## **SERVICE TECHNICAL INFORMATION**

## **ONE POINT REPAIR**

: HS-JX838

Noise occurs during TV recording

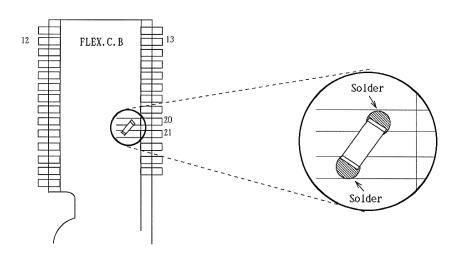
A noise caused by the photo sensor pulse signal occurs during TV recording. This noise can be detected by the REC monitor and a small amount of the noise is recorded. If this problem is

indicated by the customer, follow the remedy below.

Add a  $0.1\mu F$  chip ceramic capacitor between the Q26 collector and earth.

(Solder between the FLEX. C.B. 20 pin and 21 pin as shown in the diagram.)

Ref.	Part Name	Part No.
C130	0.1μF ceramic capacitor	87-010-831-080
